NOTICE TO GENERAL CONTRACTORS

Top Sheet  
T-86

PLAT LAYOUT - SCALE 1" = 20'-0"  
RAMSEY COUNTY HIGHWAY GARAGE  
FOR  
RAMSEY COUNTY, MINNESOTA  
SCALE NOTED - AUGUST 1948  
DRAWN BY H.S. BRONSON, REG. STRUCTURAL ENGINEER #818

RAMSEY COUNTY HIGHWAY GARAGE

ILLUSTRATION OF ALTERNATE NO. 3 (GENERAL CONSTRUCTION) - SCALE 1"=20'-0"

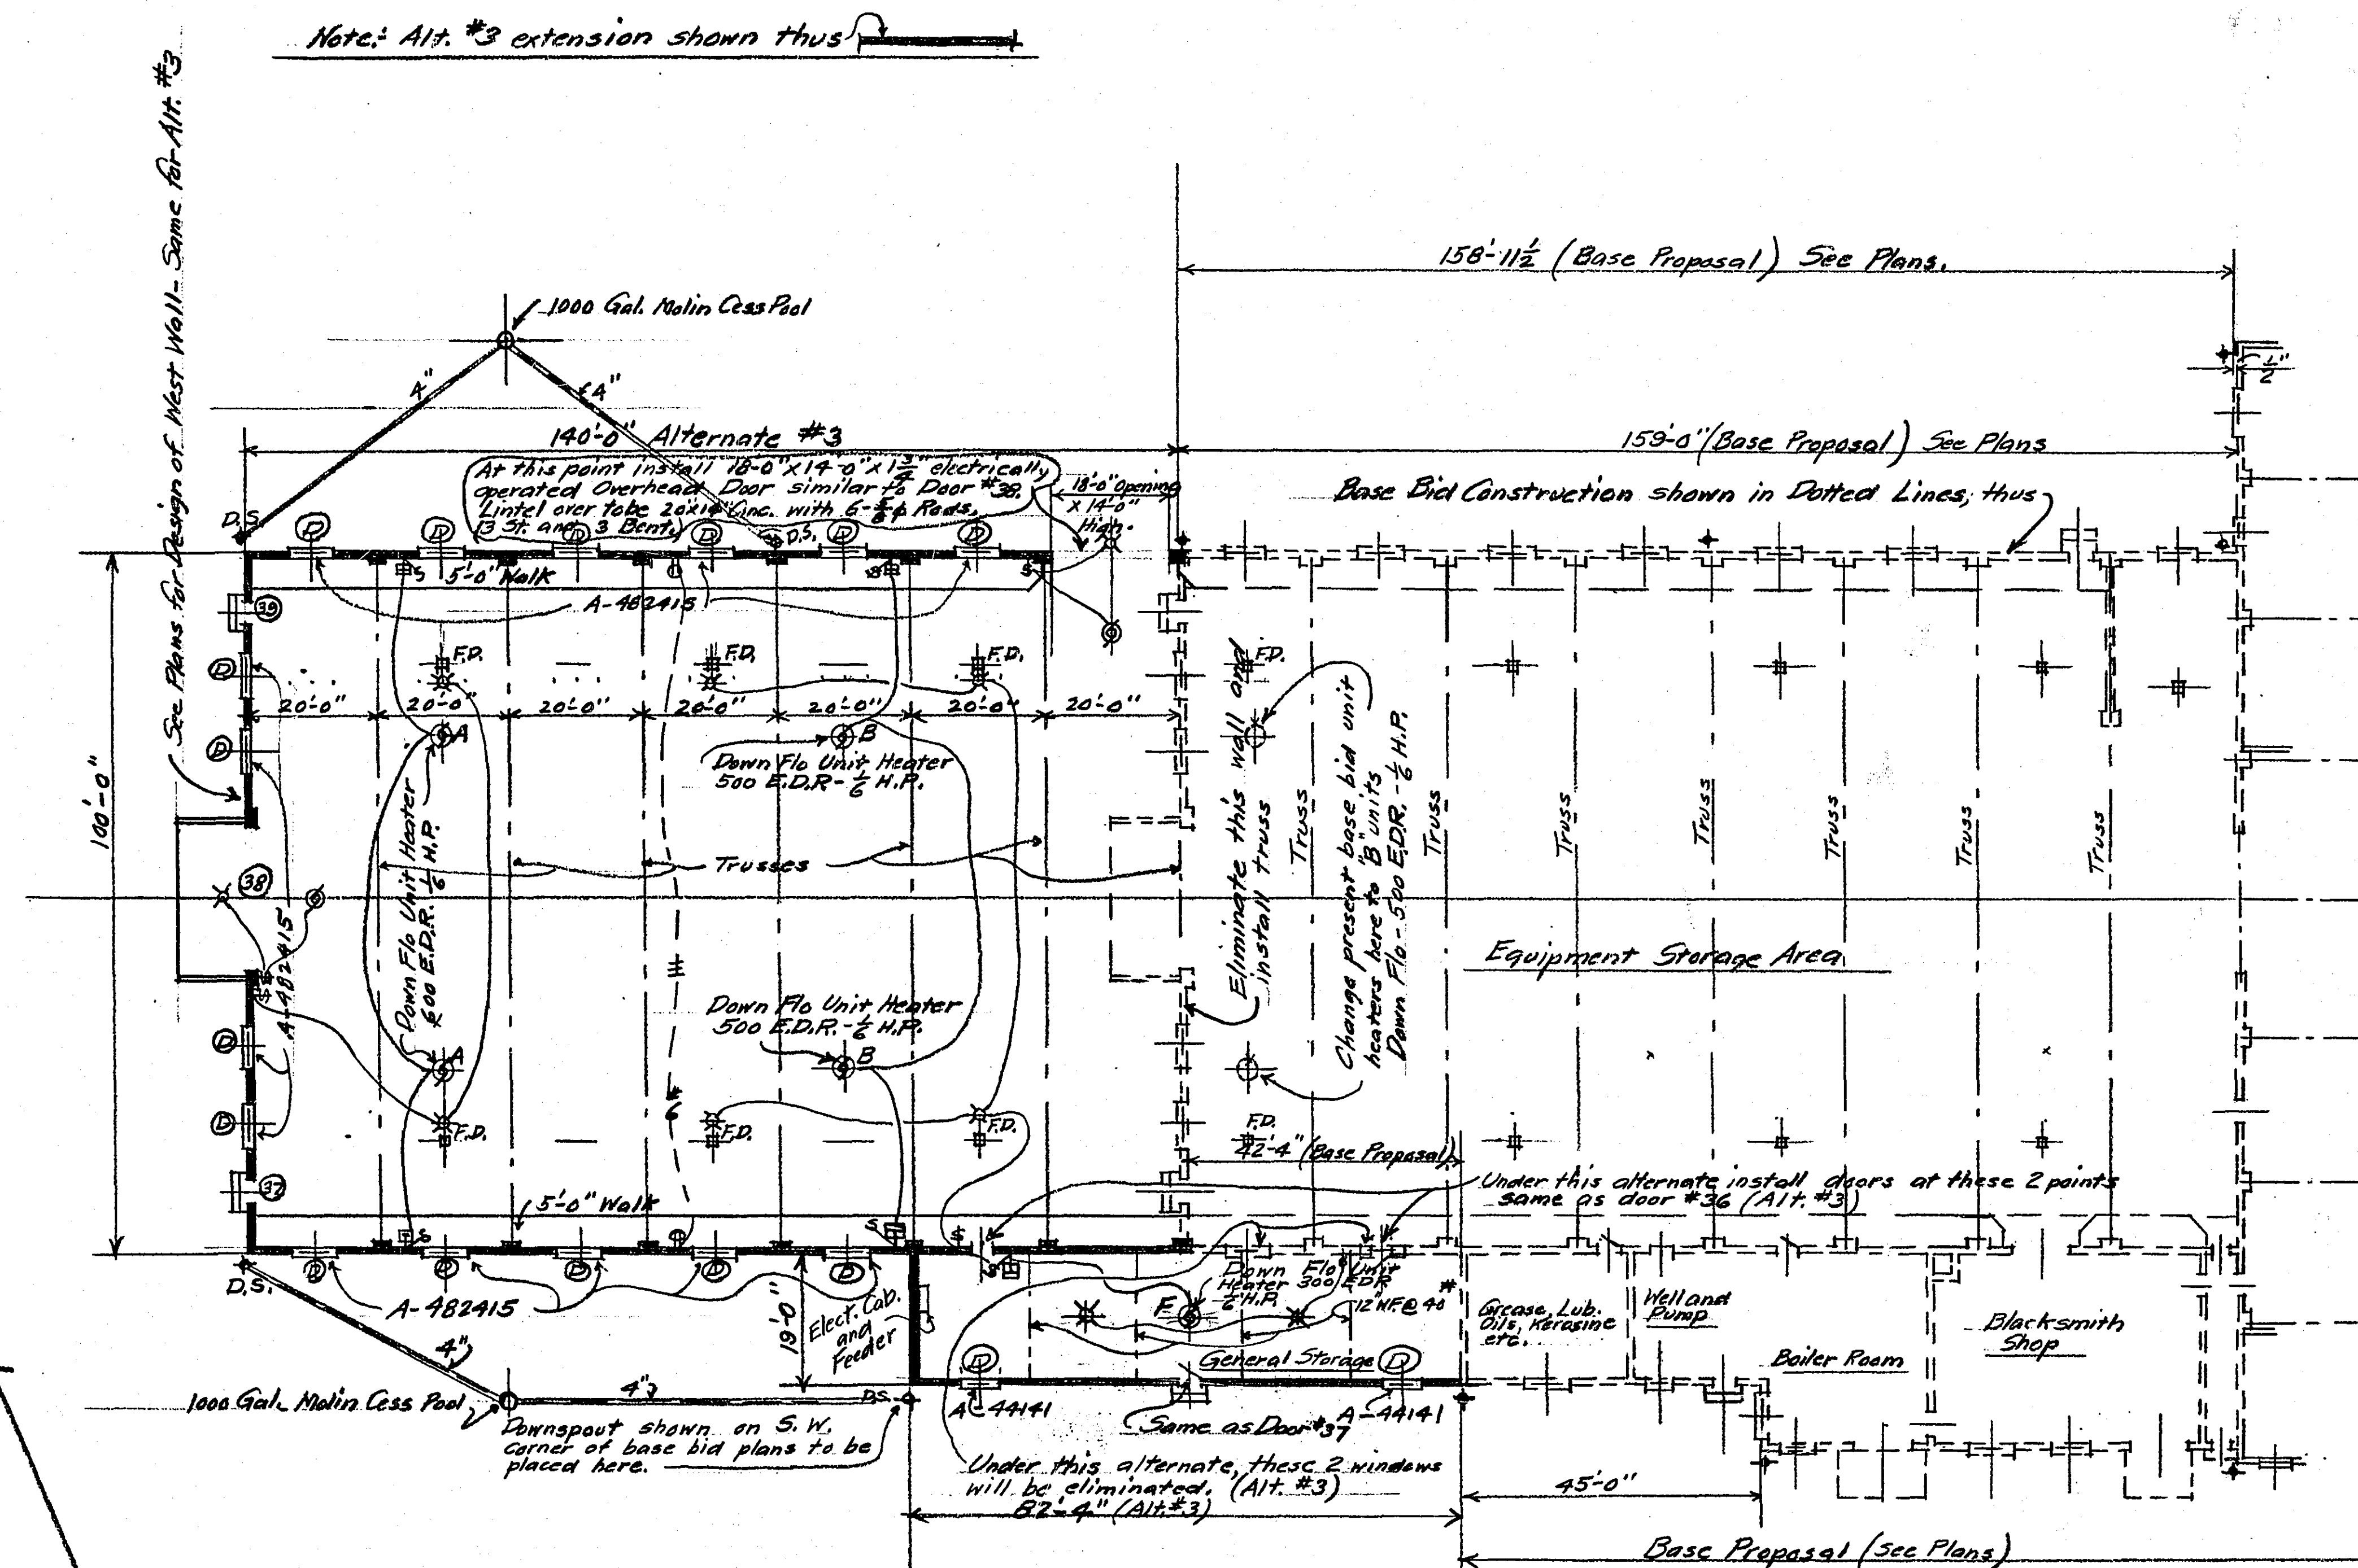
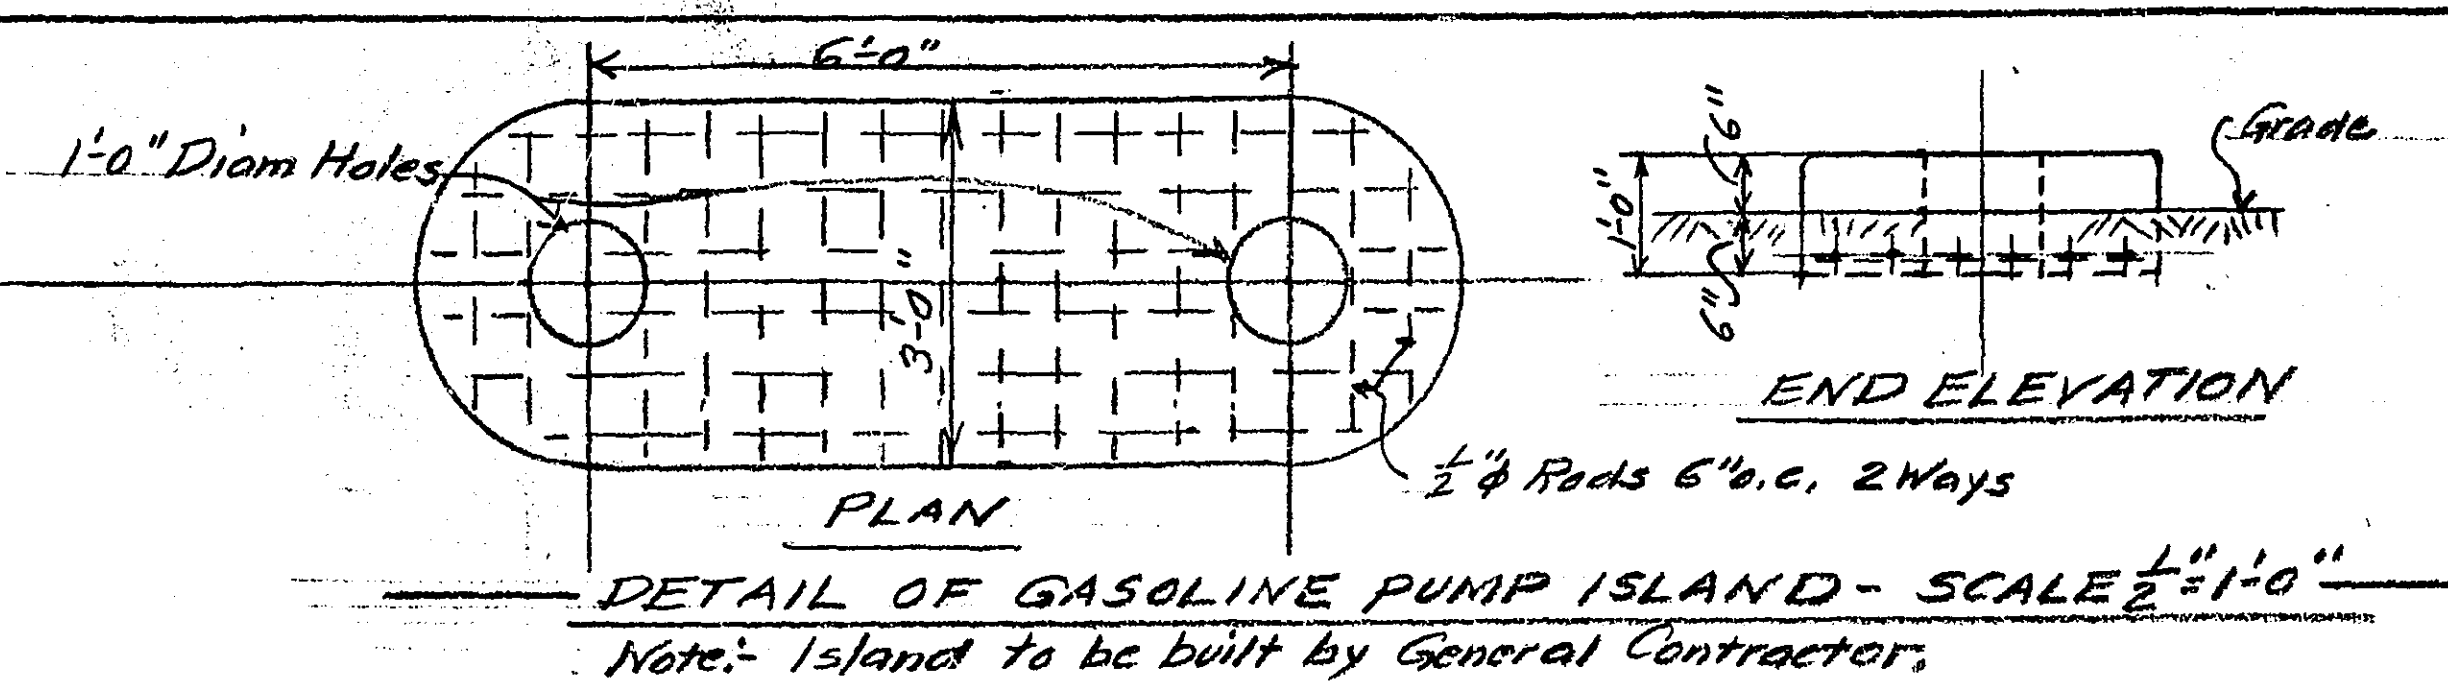
General Construction Alternate No.3:-

General Contractor will quote additional cost to Ramsey County in his bid, based on an extension of the Equipment Storage Area westward a distance of 7-20'-0" bays or 140'-0". This will produce a total length of Equipment Storage Area equal to 239'-0" instead of the 159'-0" shown on base bid plans.

Under this alternate, there will also be included a room to be known as "General Storage" which will be continued westward from the Grease, Lub. Oils, Kerosene etc. room. Footings, Foundation Walls, Additional Trusses, Floor Slab, Roof Construction, Roofing, Gutters, Downspouts etc. will all be same as shown on base bid plans, and specified.

Included in Alt. No 3 will be an 18'-0" x 14'-0" x 12'-0" electrically operated vertical lift door with supporting framework to be erected by General Contractor, similar to Door No. 38. See Specs. of Sheet #6 of plans.

All walls to be of 12" Concrete blocks as specified on Sheet #6. Provide pilasters under truss ends, as detailed in Base Bid plans.

Use method shown on Sheet #2 for Expansion Joints in Floor Slab and for pitching floor slab to Floor Drains.

All Specifications on Sheets #6 and #7 of Base Bid plans will apply to this Alternate.

Construction of "General Storage" Room will be same as shown, detailed and specified in Base Bid plans for Grease, Lub. Oils, Kerosene etc. Room.

See this sheet for location of additional downspouts required under Alternate #3.

Do not include Alternate No. 1. or Alternate No. 2 in this Alternate.

Plumbing and Heating Alternate No. 2:-

Plumbing and Heating Contractor will quote additional cost to Ramsey County in his bid based on an extension and addition to the building as shown on this sheet and described above under "General Construction Alternate No. 3". This will entail additional work over and above work to be done under base bid as follows:

- Furnish and install five (5) additional unit heaters as shown on plan on this sheet.
- Change two (2) present base bid unit heaters to sizes and types shown on this sheet.
- Extend all piping shown on base bid plans to above mentioned heaters, pipe sizes to be such as will develop full capacities of heaters.
- Provide floor Cock and Air outlet at door #38 and also at new 18" x 14" x 12" north entrance door. All to be properly connected to source of supply.

All specifications on Sheet #13 of base bid plans will apply to this Alternate. Note also that two (2) additional 1000 Gallon Main Cess Pools will be required with drain pipe from downspouts as shown on this sheet. These Cess Pools to have special reinforced tops.

Electrical Work Alternate No. 2:-

Electrical Contractor will quote additional cost to Ramsey County in his bid based on an extension and addition to the building as shown on this sheet and described above under "General Construction Alternate No.3". See plan on this sheet for additional lights, power plugs and motor wiring necessary under this alternate. All Specifications covering base bid which apply to Sheet #14 will apply to this Alternate. Contractor will supply and erect an additional cabinet and feeder of proper size where shown in General Storage Room. Do not include Alternate No.1 in this Alternate.
